DOCUMENT 00 90 00
ADDENDUM

ADDENDUM No.: 1

DATE: September 19, 2024

RE: VIROQUA HOUSING AUTHORITY
PUBLIC HOUSING PROJECT WI 118
200 PARK VIEW COURT
VIROQUA, WI 54665
PROJECT NO. 24012

E100

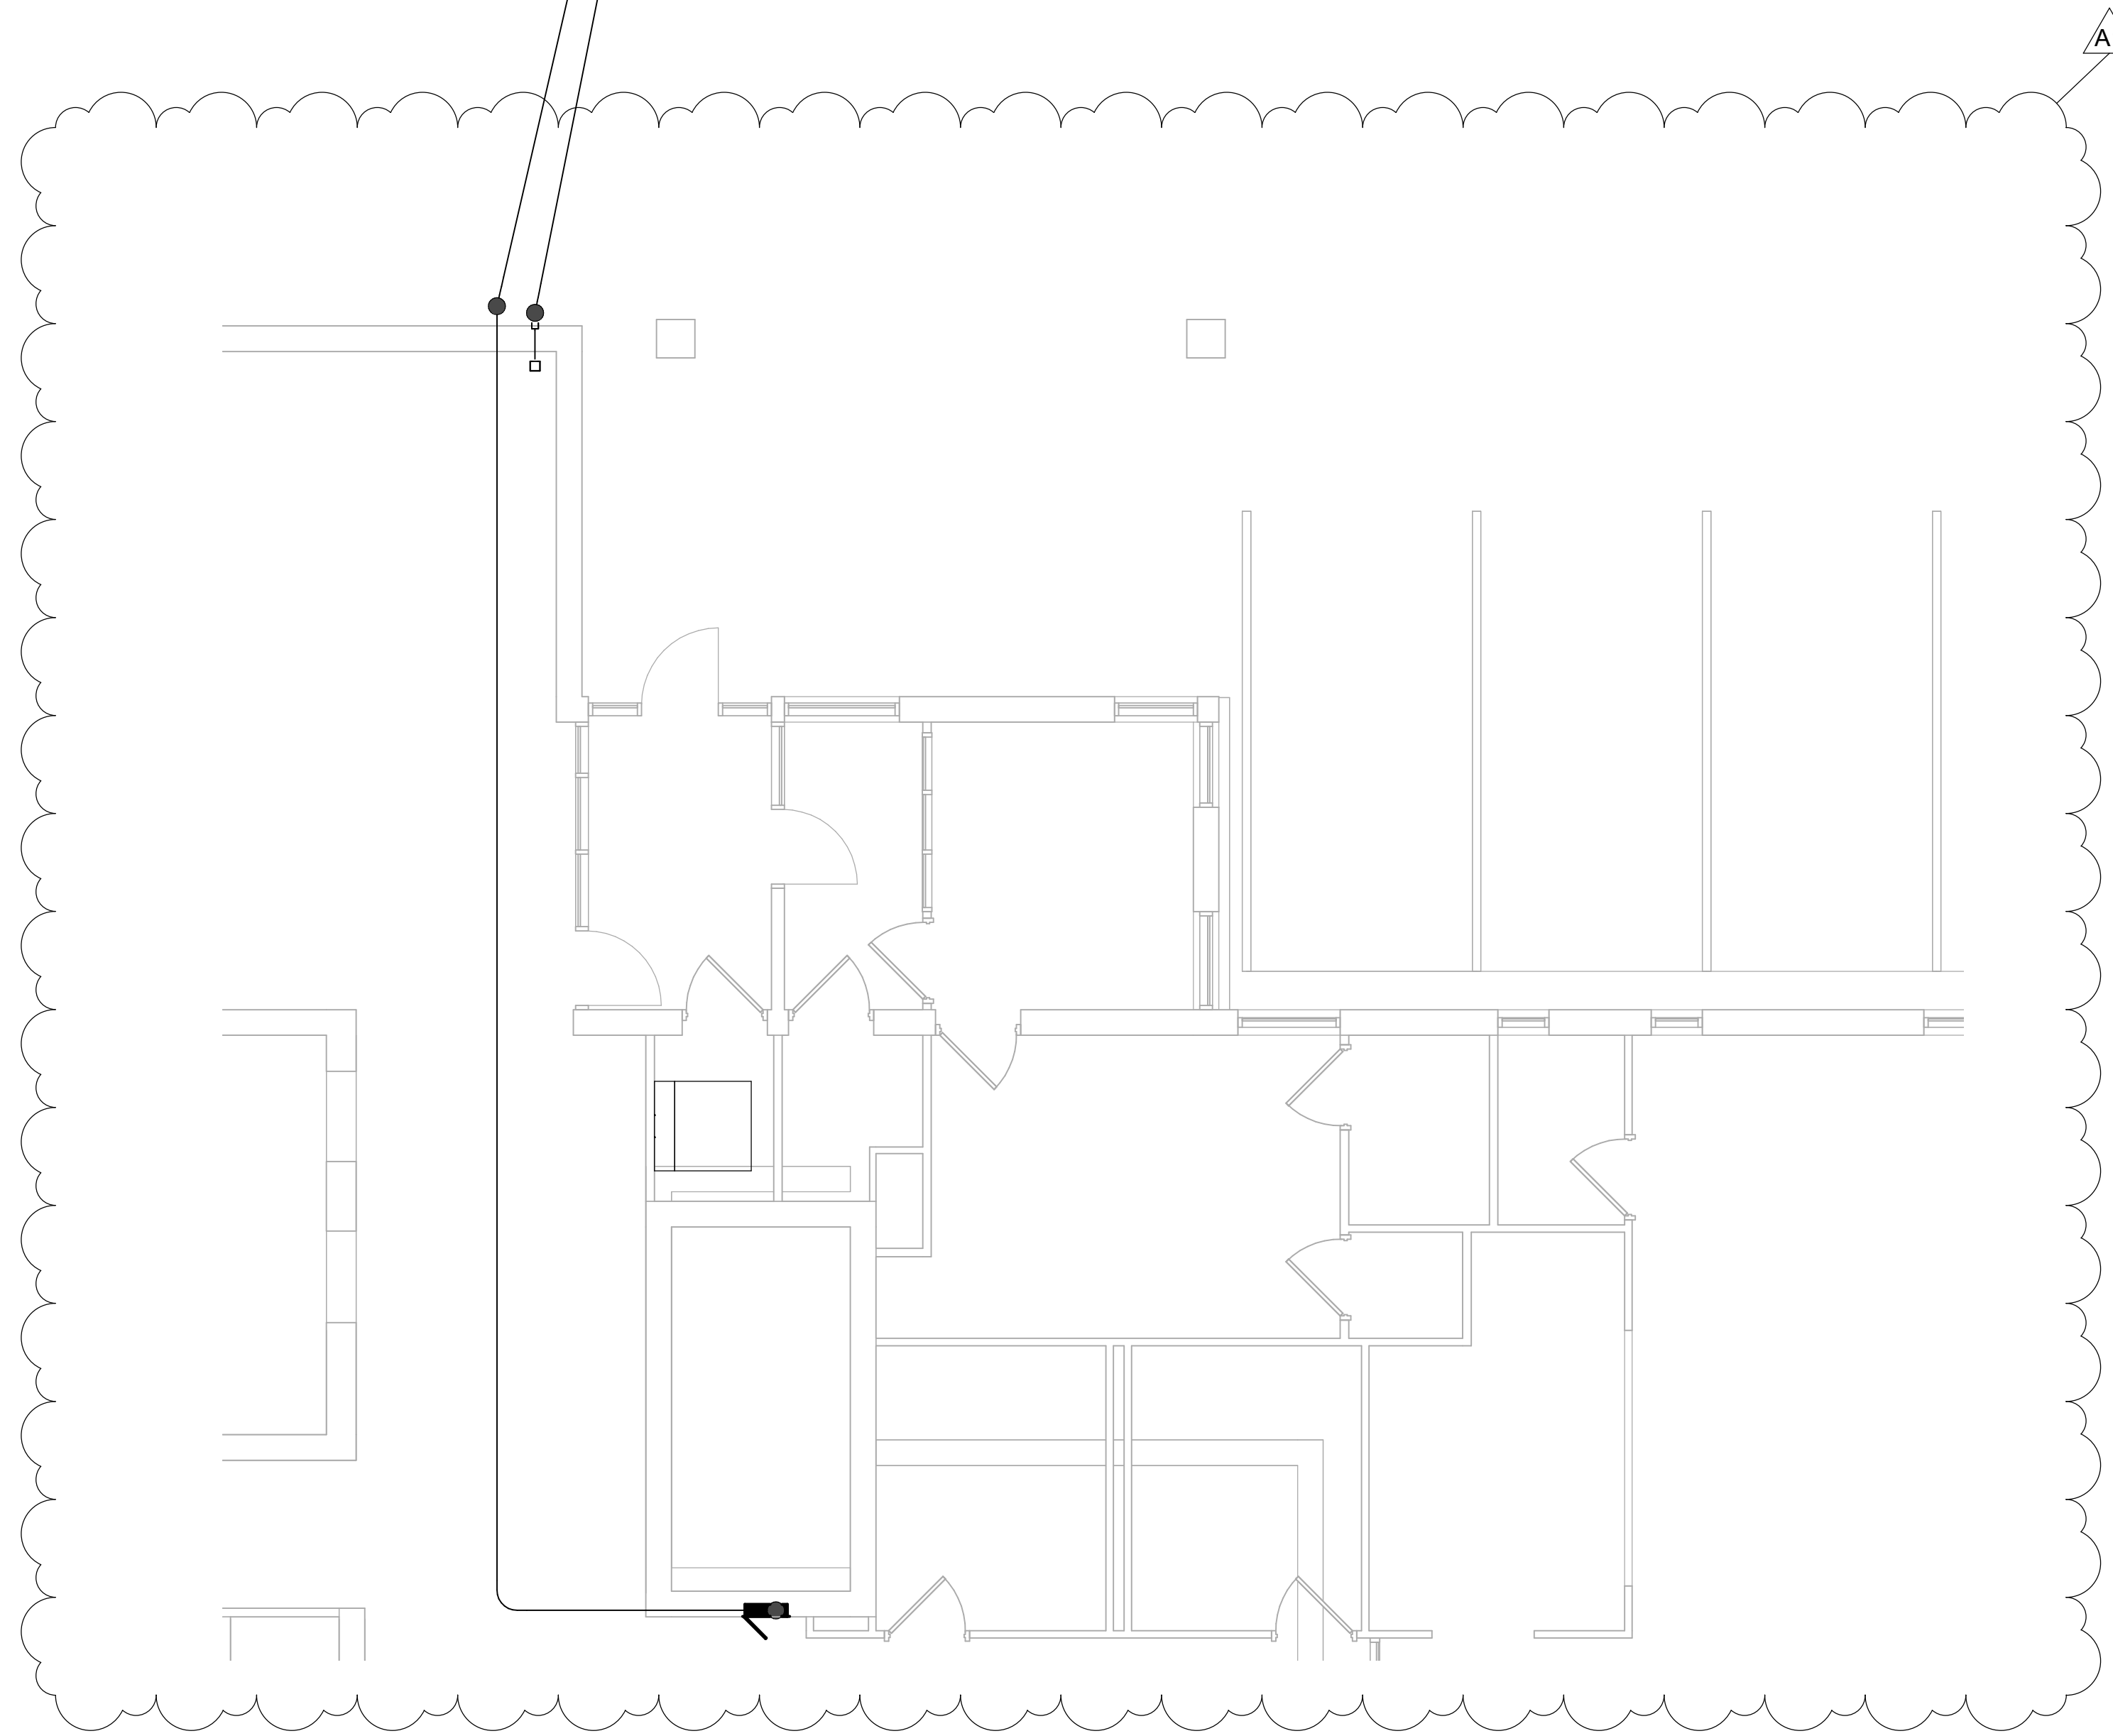
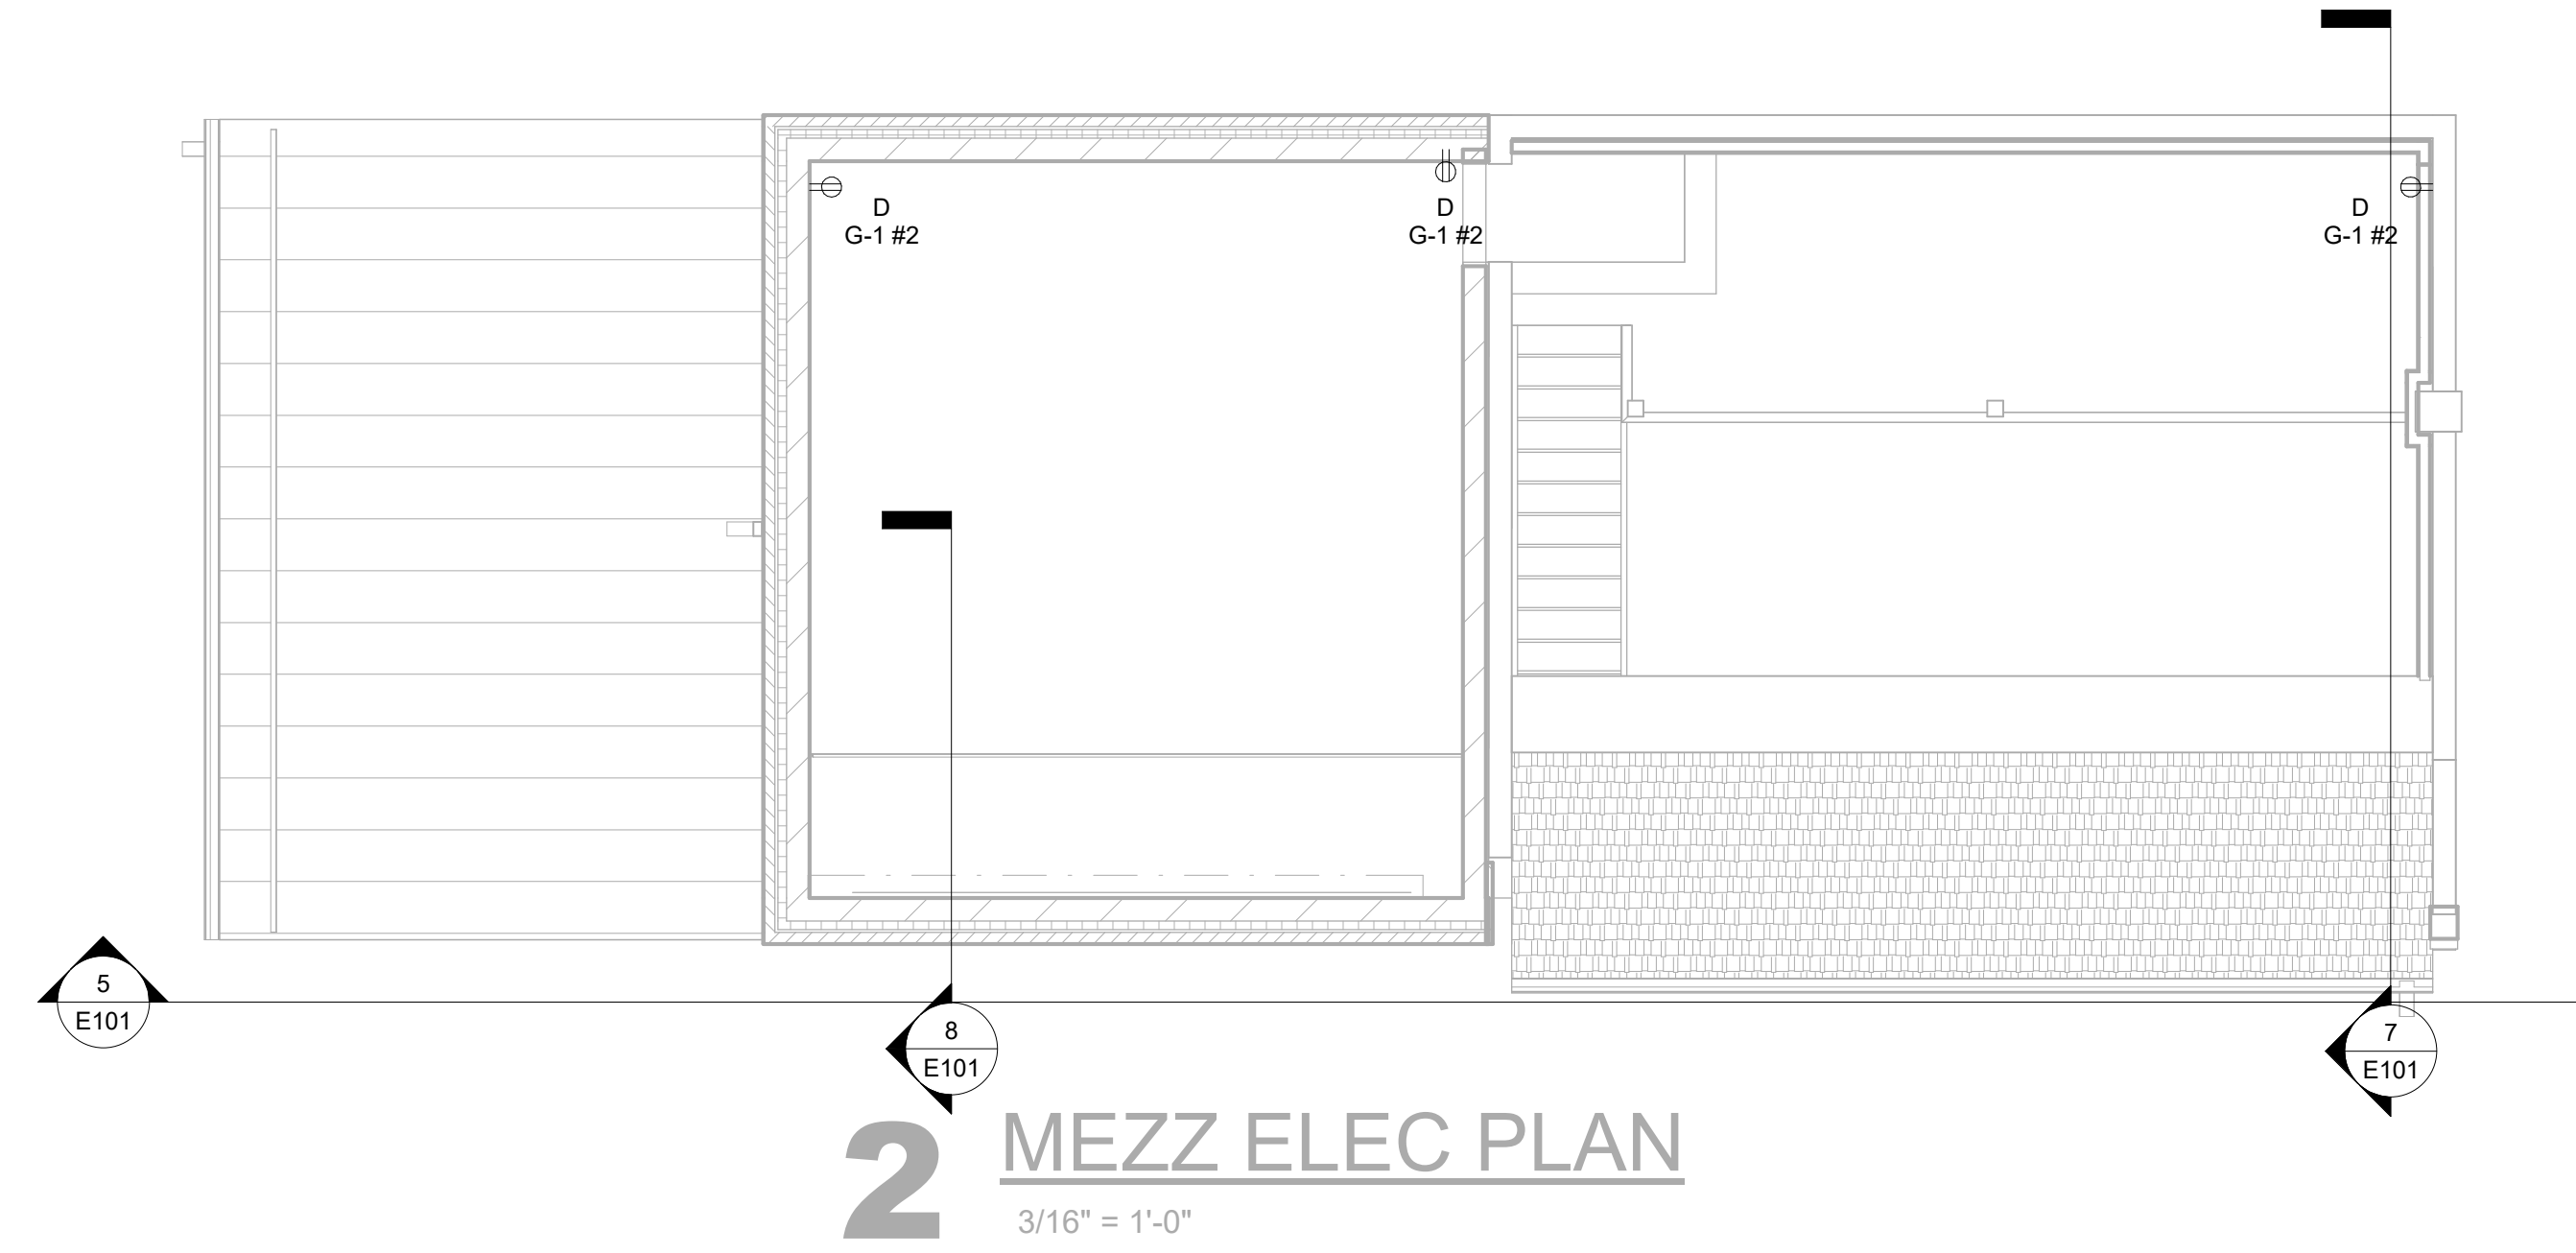
- b. Added Roof Elec Plan.
 - c. Added plan to show location of panelboard A1.
14. Sheet E101 ELECTRICAL PLAN 30"x42"
 - a. See the revised sheet included in this addendum. Disregard the previous version.
